# **DRAINAGE IMPACT ASSESSMENT REPORT**

**PROPOSED TEMPORARY WAREHOUSE (STORAGE OF CONSTRUCTION MATERIALS, METAL AND ELECTRONIC PARTS) AND OPEN STORAGE OF CONSTRUCTION MATERIALS FOR A PERIOD OF 3 YEARS**

Report no. SDP/HT/001C

## Response to DSD's comment on 2<sup>nd</sup> December 2024

CATCHMENT AREA PLAN FOR EX. STREAM

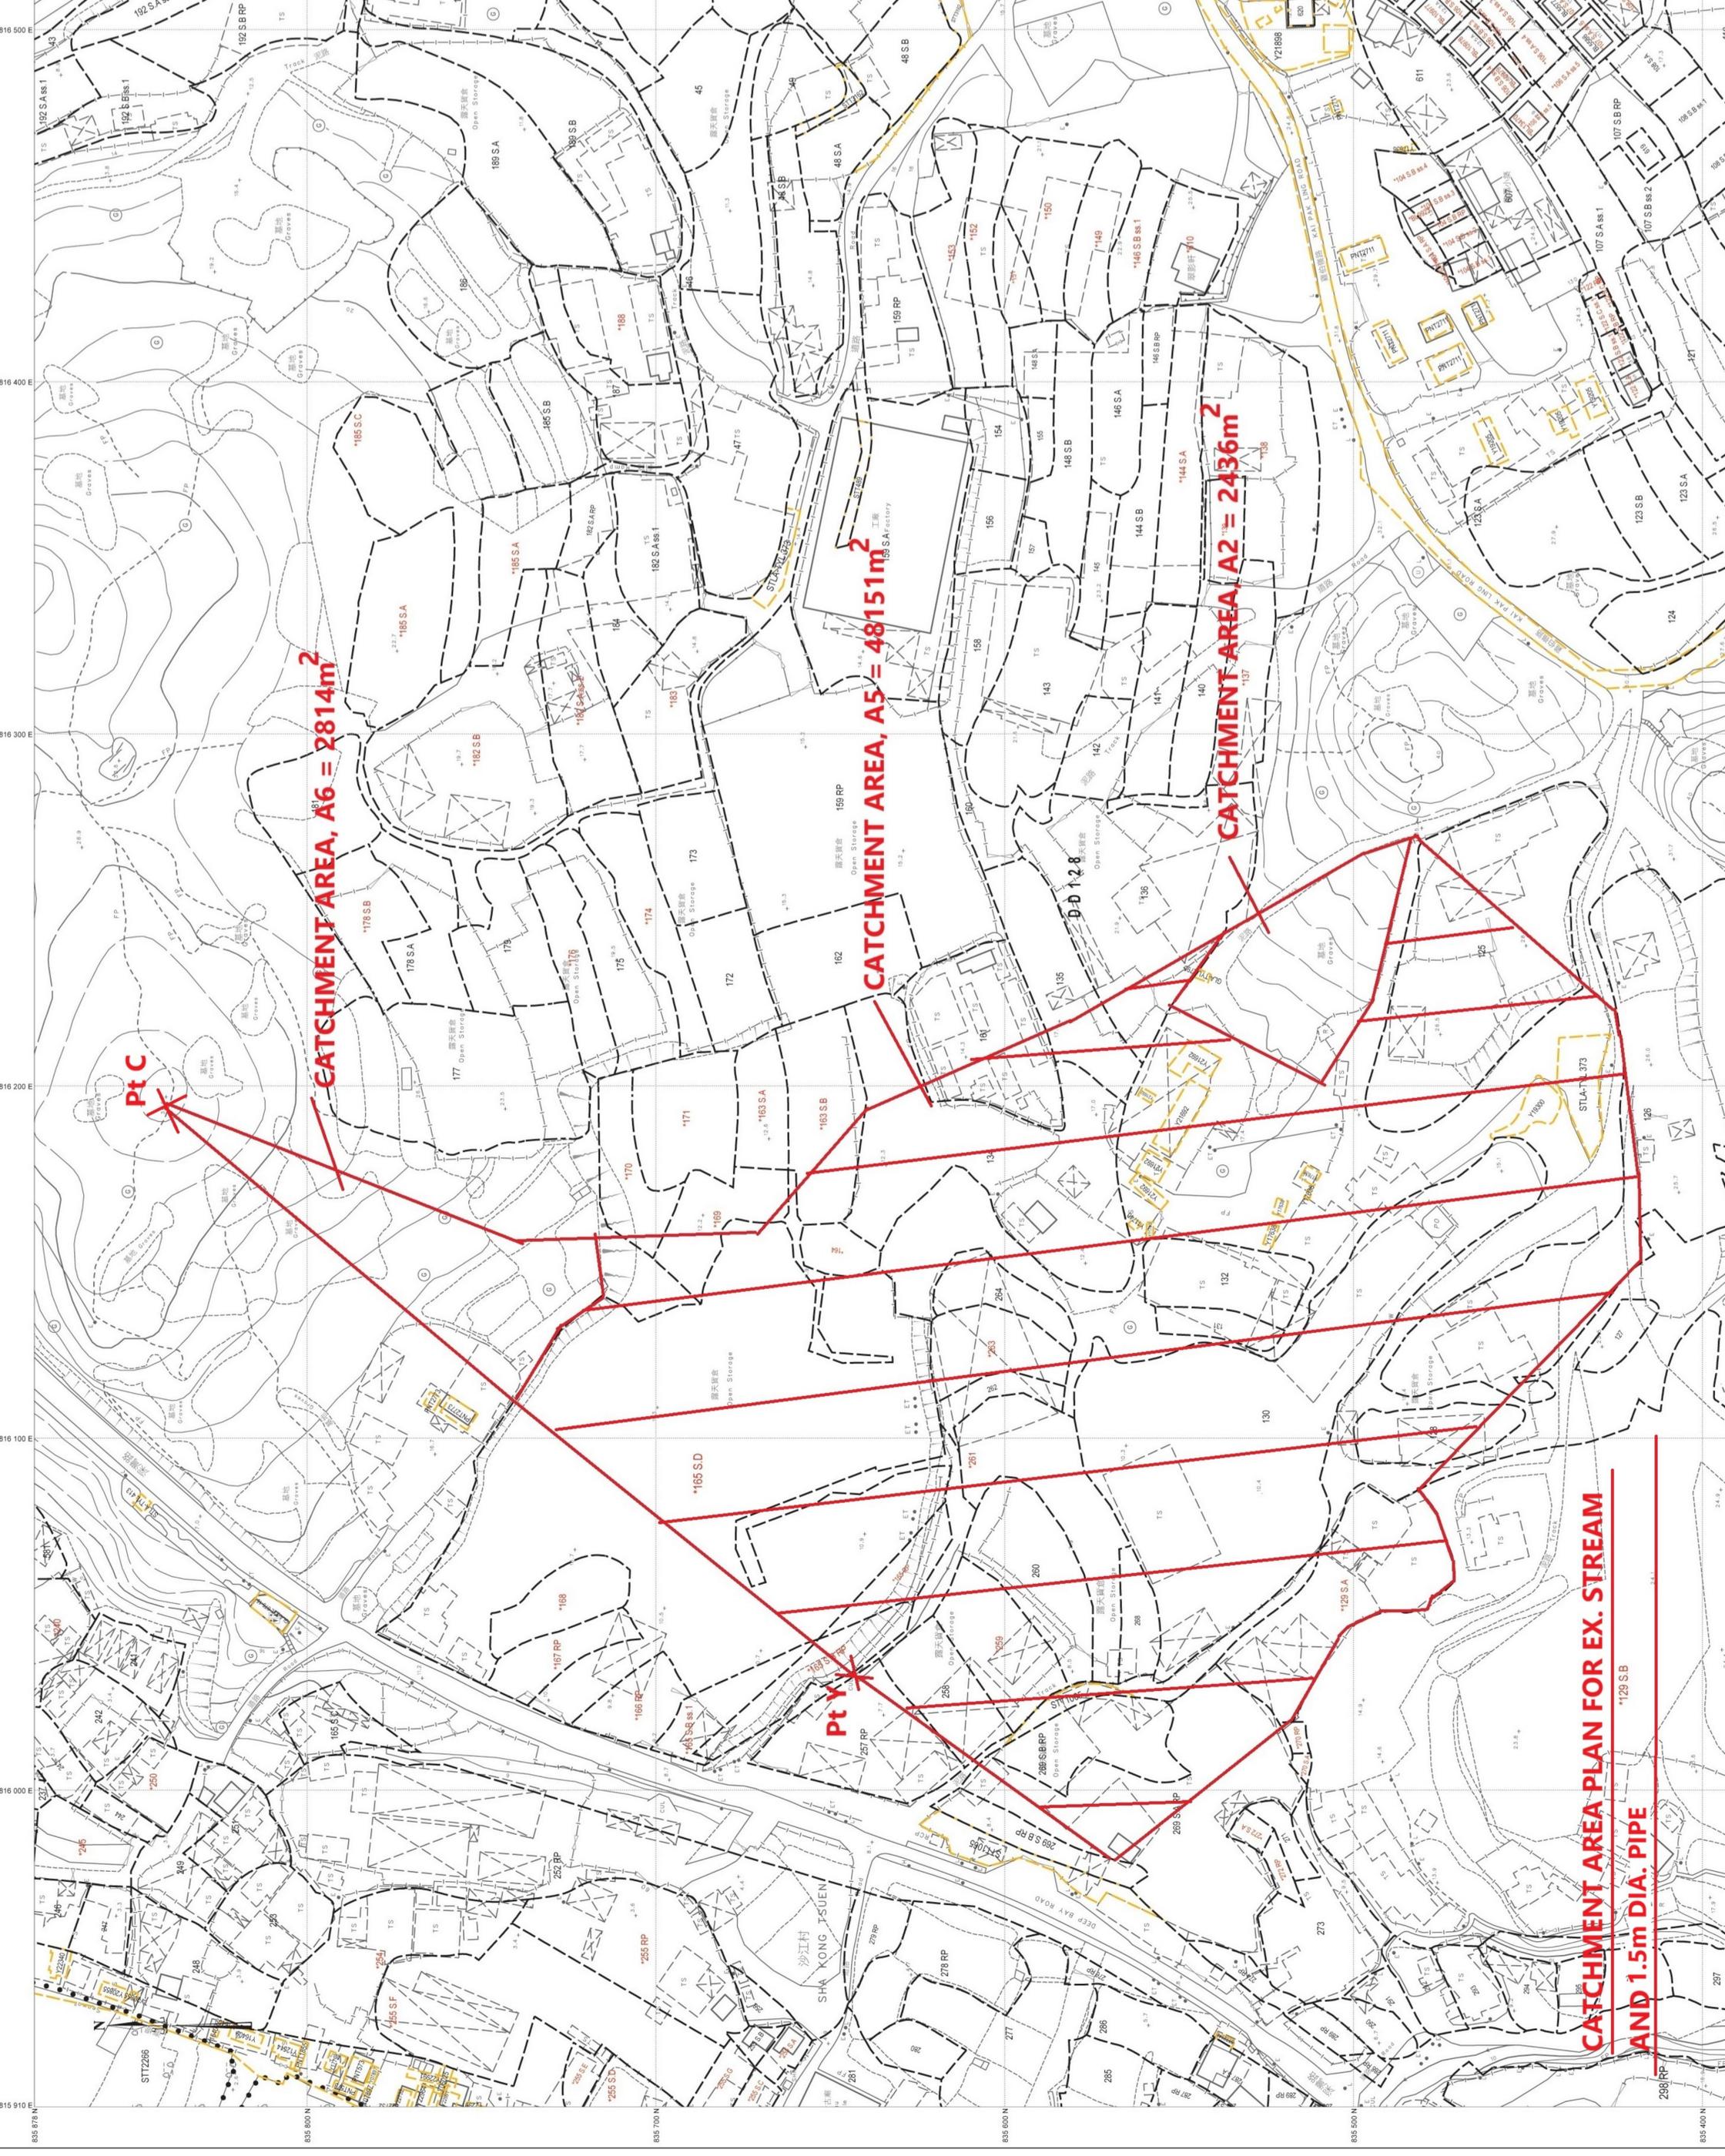
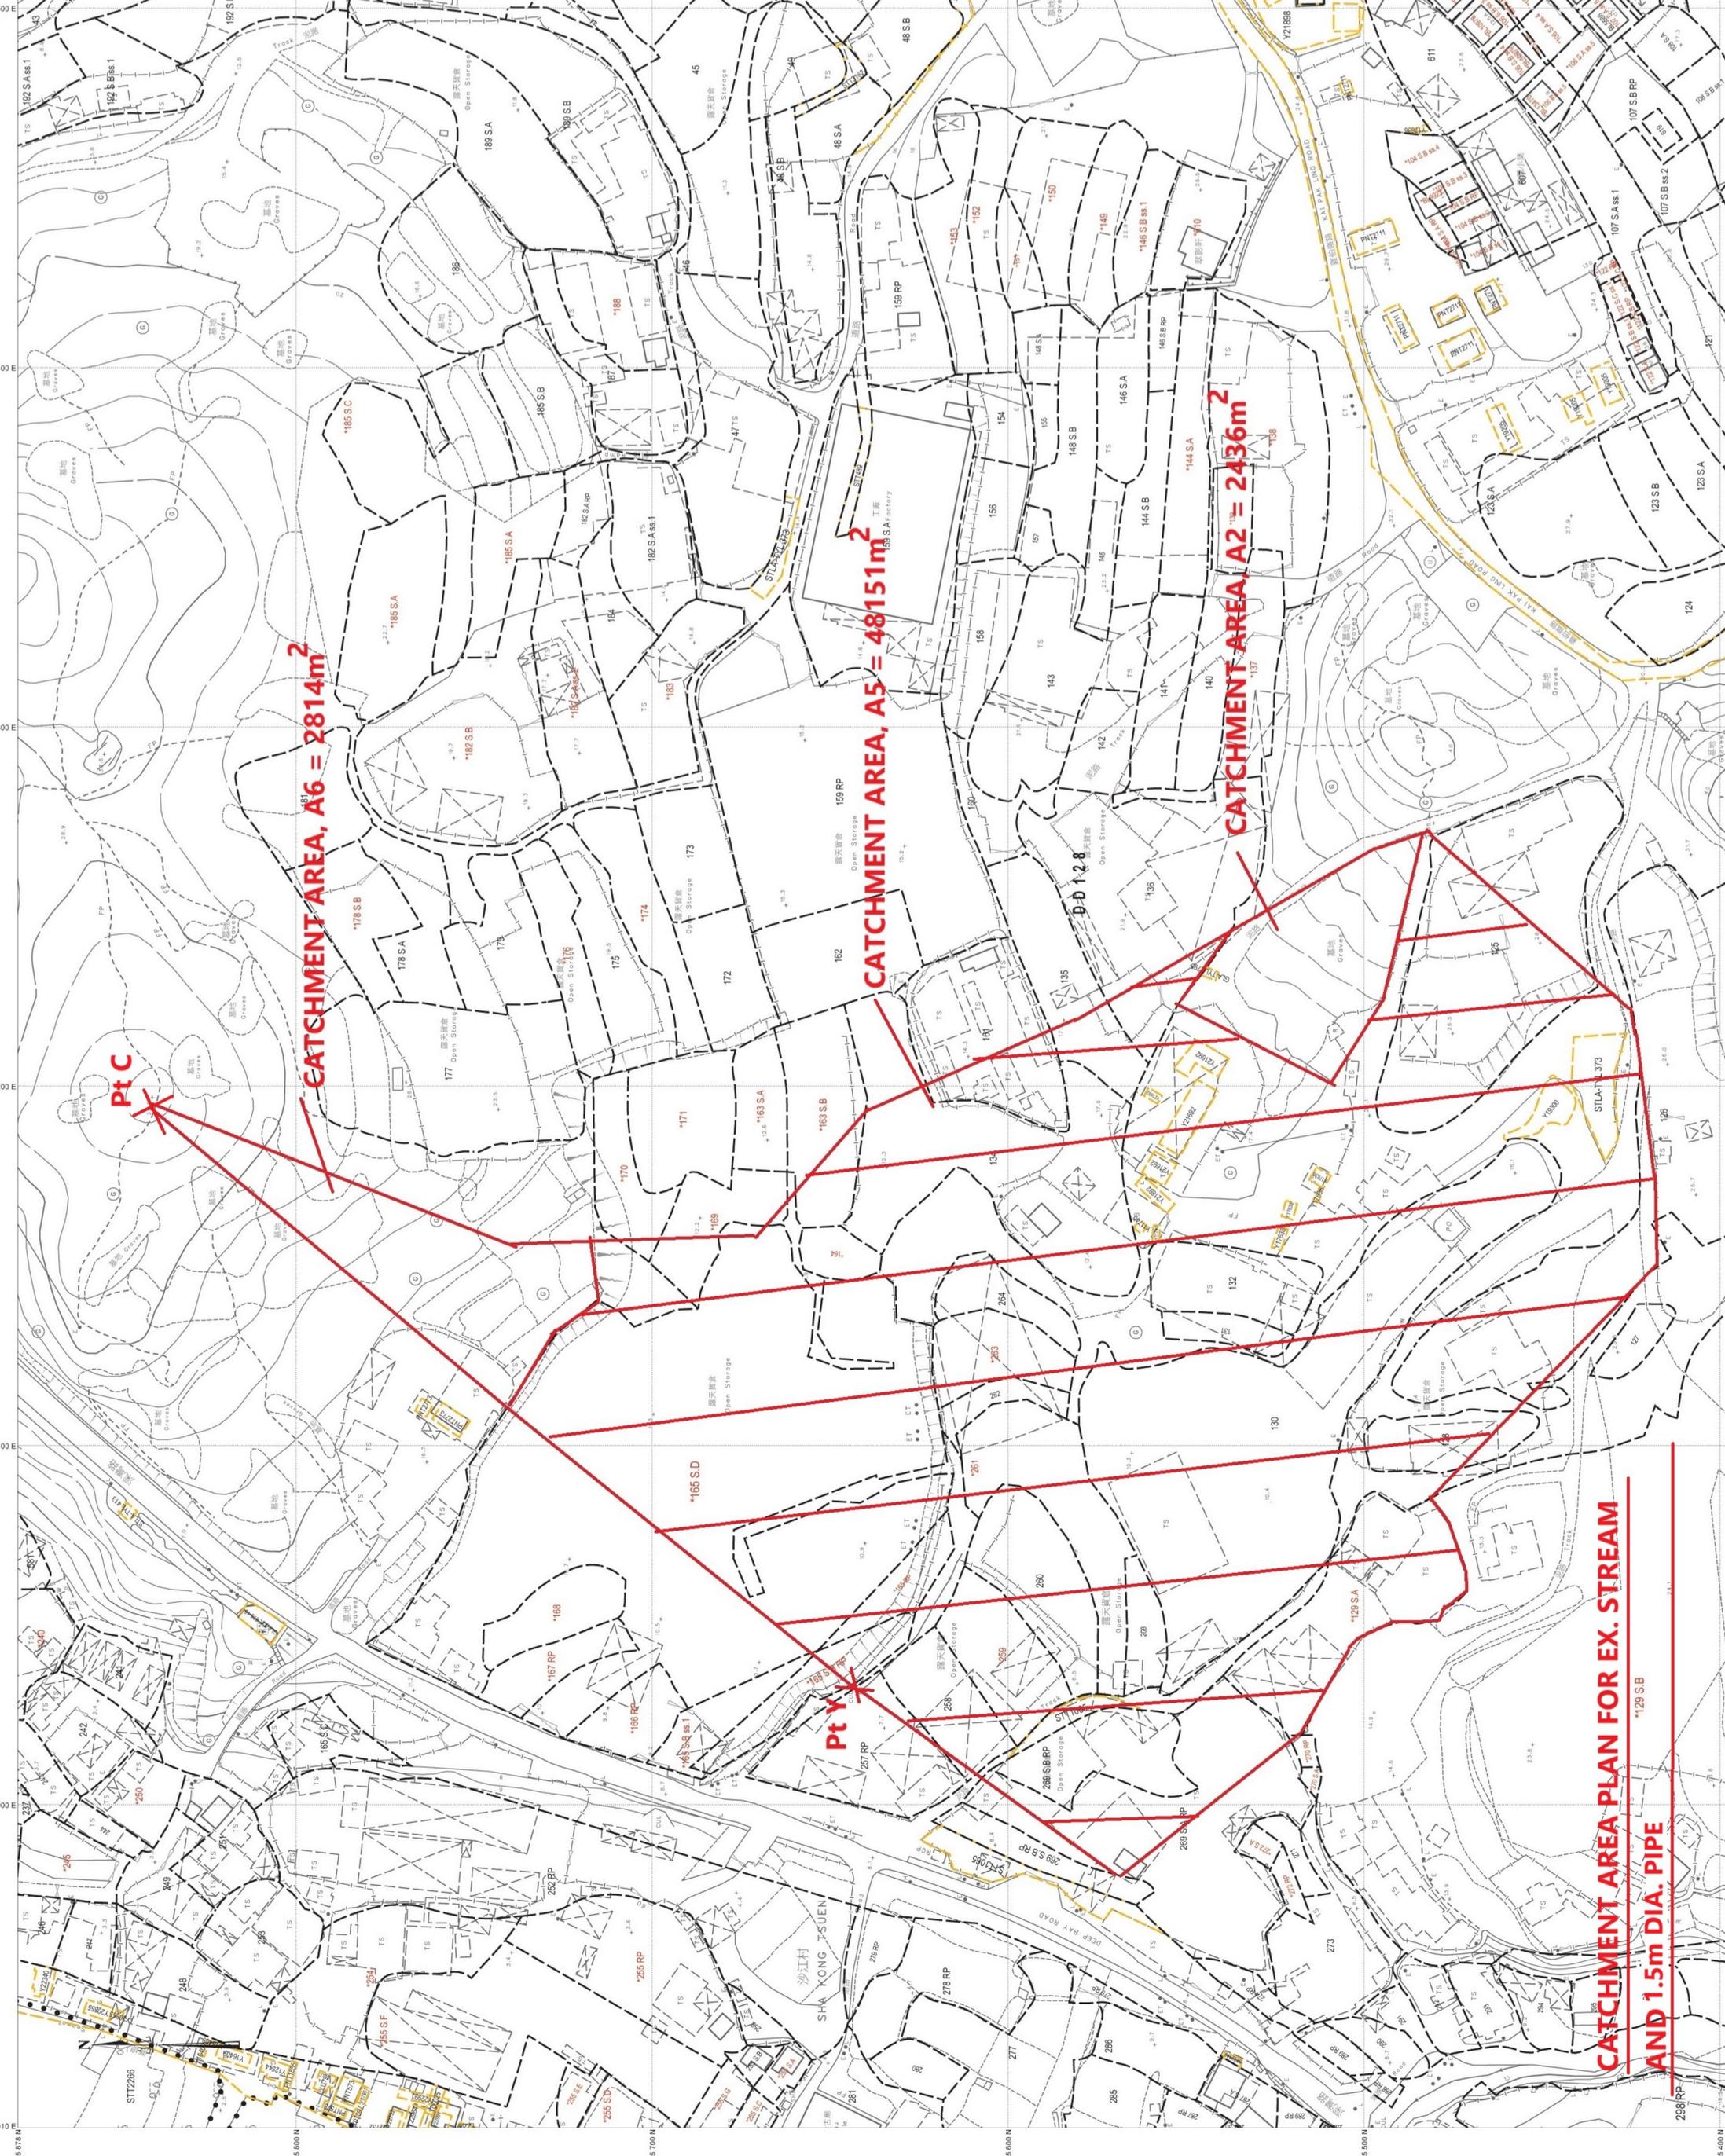
Item	DSD's comment	Response to comment
1	Please advise the location of the box culvert on the location plan, and advise the drainage flow path from the subject site to the public drainage system/streamcourse/sea/any recognized drainage facilities shown in the Lands Department's map in association with supporting site photos	The location of 1.5m dia. underground pipe and the drainage flow path from the subject site to the streamcourse is shown on the drainage plan. The site photo of the existing stream and 1.5m dia. underground pipe is appended in Appendix C.
2	Please provide photos of the box culvert to demonstrate the dimensions (including height) of the box culvert	The photo of the existing 1.5m dia. underground pipe is shown photo no. V6 and V7 as appended in Appendix C.
3	In the photo of the existing box culvert, it is noted that the box culvert is full of vegetation and therefore, the calculation could not reflect the actual condition.	The photo of the existing 1.5m dia. underground pipe is shown photo no. V6 and V7 as appended in Appendix C.

### **Photo of Existing Stream and 1.5m Dia. Pipe**

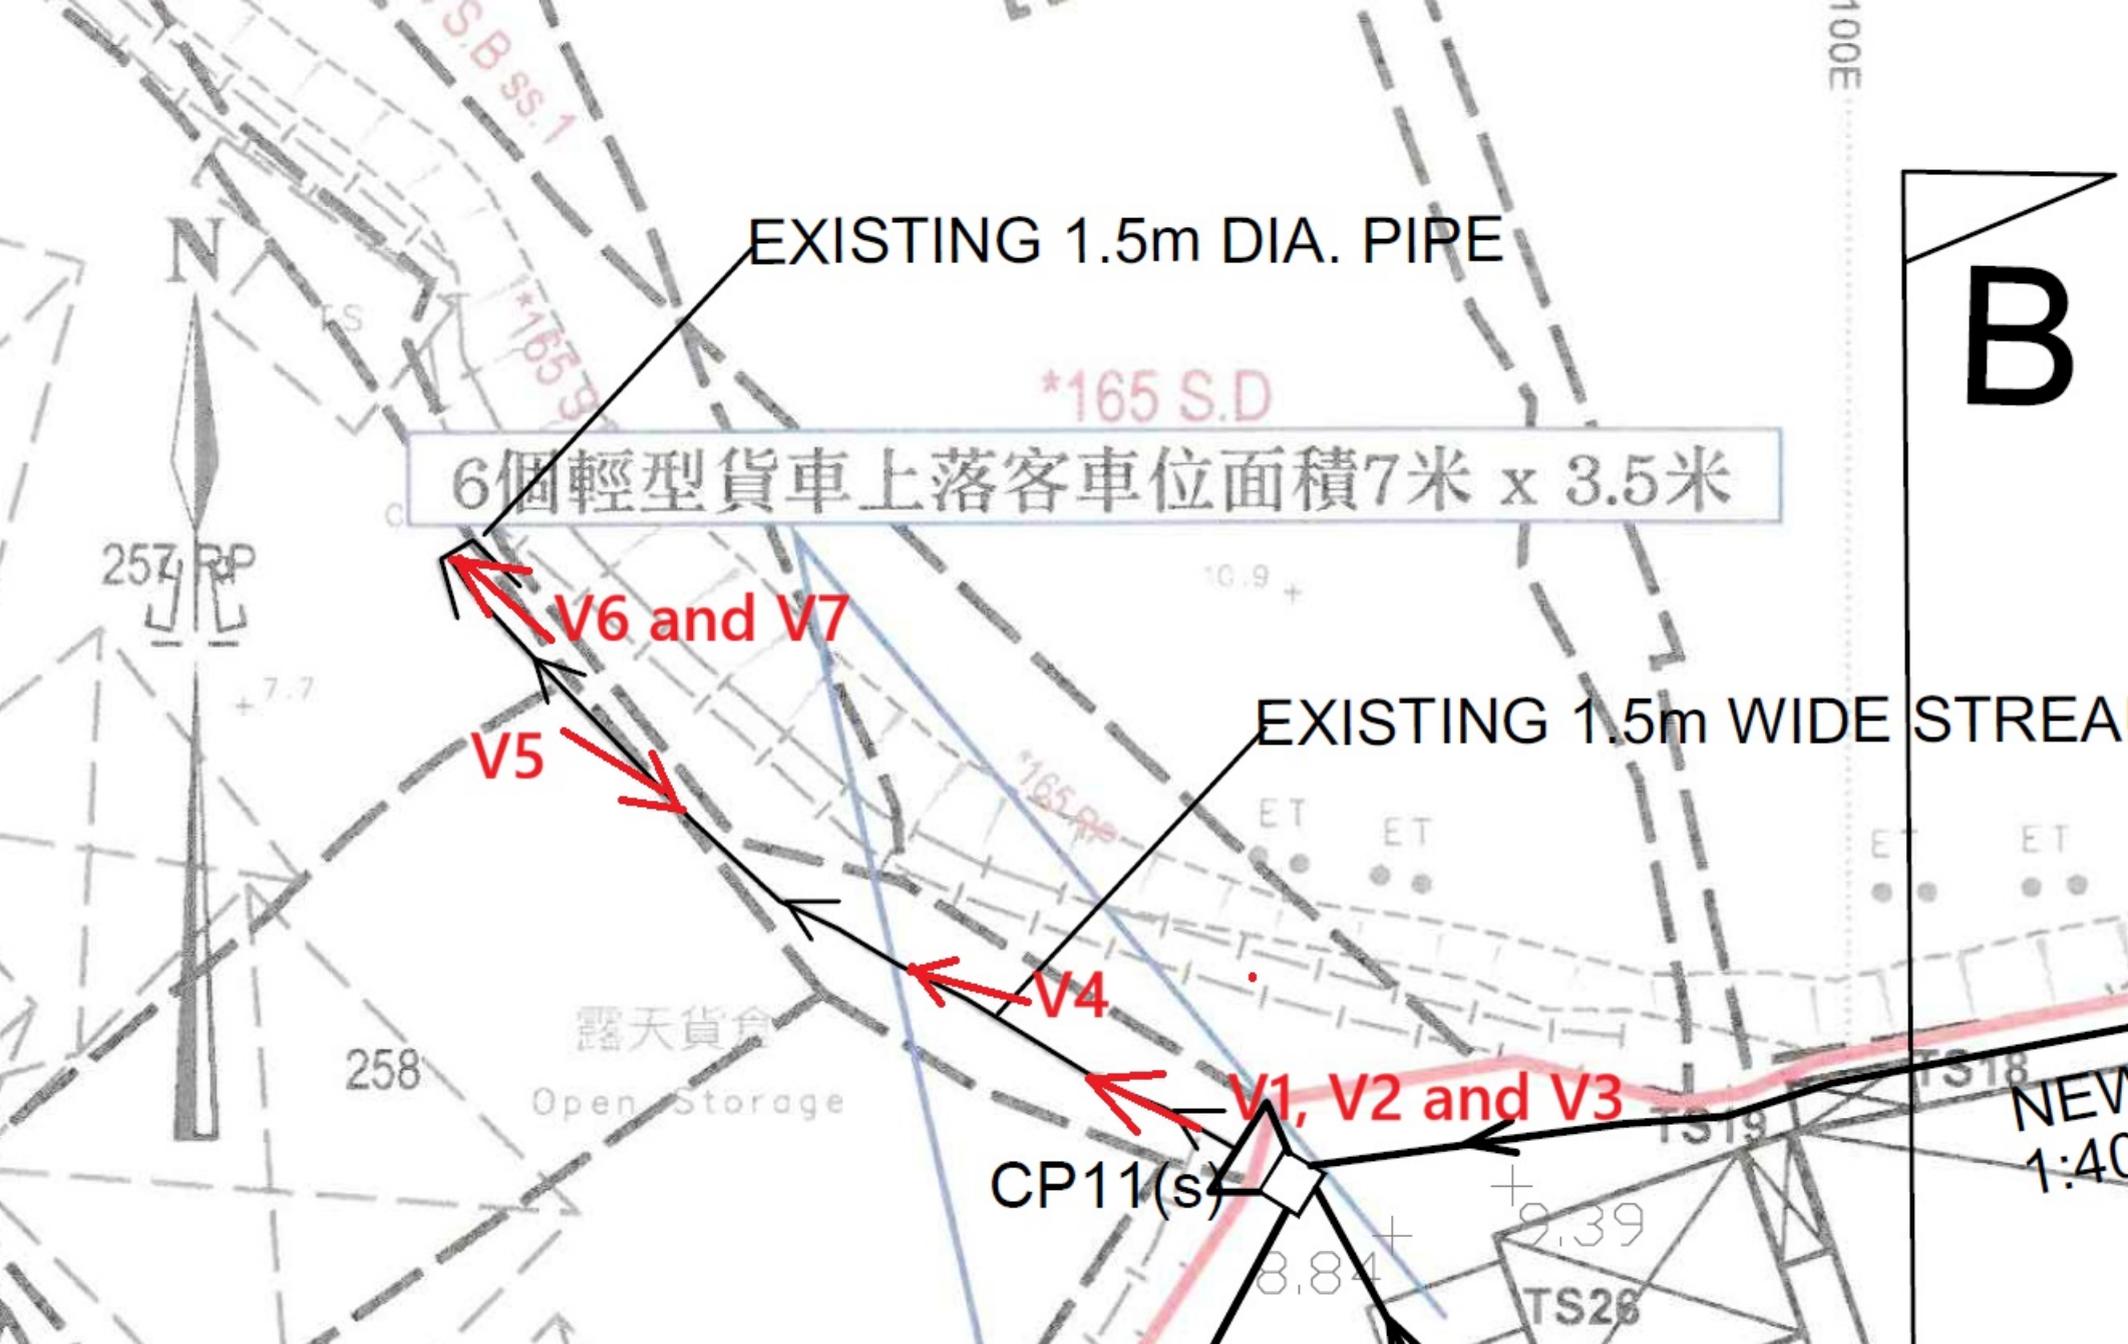
4	Please provide photos of the existing streamcourse at different sections to demonstrate the dimension of the streamcourse	The photos of the existing streamcourse is shown photo no. V1 to V5 as appended in Appendix C.
5	Please refer to DSD's Stormwater Drainage Manual (SDM) including SDM Corrigendum No. 1/2024 regarding rainfall intensity	The estimation of rainfall intensity is revised in accordance to SDM Corrigendum No. 1/2024 in this resubmission
